<b>DOCKETED</b>	
<b>Docket Number:</b>	23-AFC-03
<b>Project Title:</b>	Black Rock Geothermal Project (BRGP)
<b>TN #:</b>	257276
<b>Document Title:</b>	Black Rock Geothermal LLC Responses to Jobs to Move America Comments on the ICAPCD PDOC
<b>Description:</b>	N/A
<b>Filer:</b>	Lindsey Xayachack
<b>Organization:</b>	Jacobs
<b>Submitter Role:</b>	Applicant Consultant
<b>Submission Date:</b>	6/21/2024 12:57:40 PM
<b>Docketed Date:</b>	6/21/2024

RE: **Selected Responses to the Jobs to Move America's Public Comments on Black Rock Geothermal Facility Preliminary Determination of Compliance (PDOC)**

Figure I.2-1  
Comparison of Wind Roses  
Black Rock Geothermal Project  
Imperial County, California

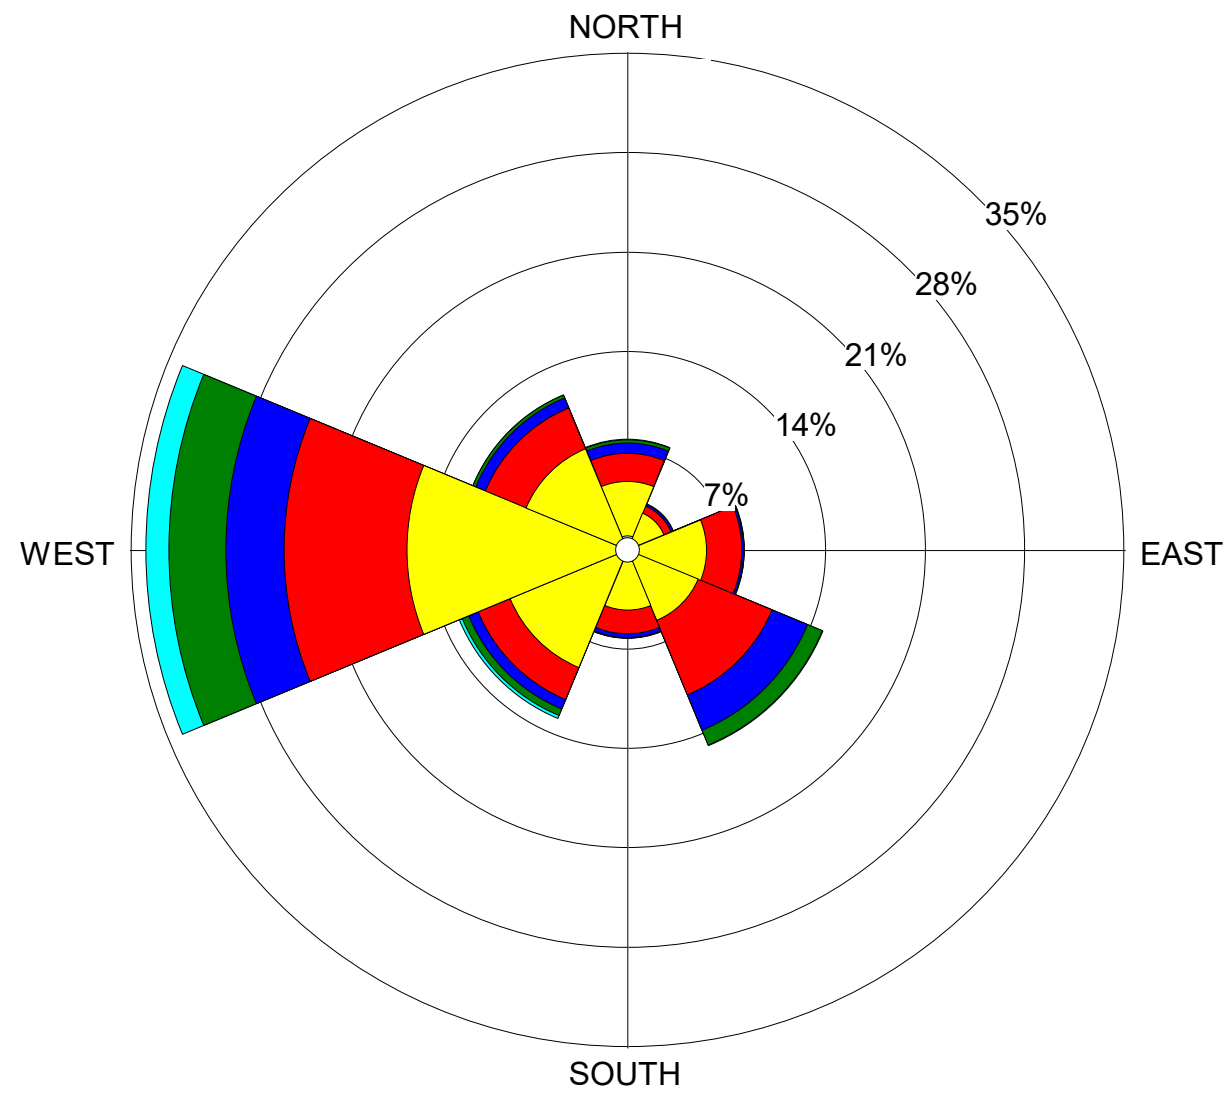
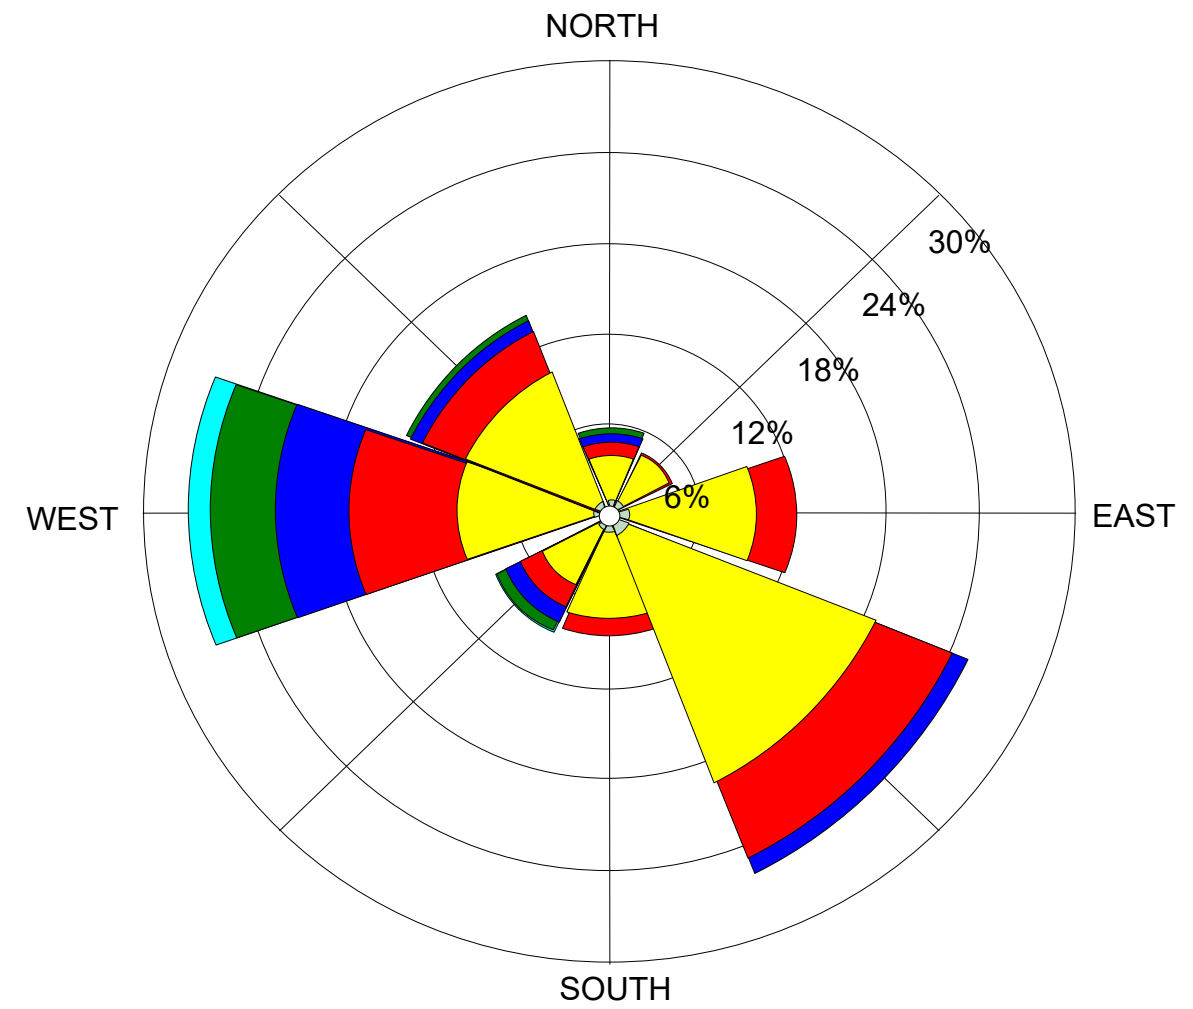
2. *The PDOC should also rely on data from monitoring stations closer to the project development site to develop its air quality analysis. Page 27 of the PDOC states that “the dispersion modeling utilized 5 years of hourly meteorological data collected at the Imperial County Airport.” The airport is approximately 25 miles away from the project site. Data from the Sonny Bono monitoring station should be used since it is approximately 5 miles away from the project site. This data will more accurately model impacts on workers and community members closer to the facility. The ICAPCD should re-model its air quality analysis using data from the Sonny Bono monitoring stations before this project moves forward.*

**Response:** The dispersion model utilized the most representative, accurate, and reliable meteorological data available, consistent with EPA Guidelines. In particular, the Applicant reviewed the meteorological data collected at the Sonny Bono monitoring station, which is the monitoring station that JMA recommended the Air District analyze within its comments.<sup>2</sup> Only two years of recent data (2020 and 2022) from that station meet the EPA requirements of 90 percent minimum completeness before substitution on a quarterly basis.<sup>3</sup> To ensure the worst-case meteorological conditions are adequately represented in the model results, the EPA requires the use of five years of adequately representative National Weather Service (NWS) meteorological data, at least one year of site-specific data, or at least three years of prognostic meteorological data.<sup>4</sup>

Lastly, although the Imperial County Airport is located over 25 miles from the project site, there are no significant geographic features between the two locations, and both are located south/southeast of the Salton Sea. The lack of significant geographic features between the two locations is itself an indicator of representativeness of the Imperial County Airport meteorological data,<sup>5</sup> but also leads to the expectation that wind speeds and wind directions in the project vicinity are similar to those incurred at the Imperial County Airport. This expected similarity is verified by comparing the wind rose for the Imperial County Airport (for years 2015 to 2018 and 2021) to the wind rose for the Sonny Bono monitoring station (for years 2020 to 2022). As shown in Figure I.2-1, attached hereto, both wind roses share the predominant wind directions from the west and southeast.

Based on the above, the meteorological data collected at the Sonny Bono monitoring station is not more suitable for modeling as the data does not meet the minimum requirements for completeness and would not be any more representative of the project site than the Imperial County Airport data based on a comparison of wind roses. Furthermore, as an ASOS station, the Imperial County Airport NWS station may provide fewer missing hours of wind speeds and wind directions. For these reasons, the Applicant supports the continued use of the Imperial County Airport NWS station meteorological data, as previously approved both by the ICAPCD and California Energy Commission (CEC).<sup>6</sup>
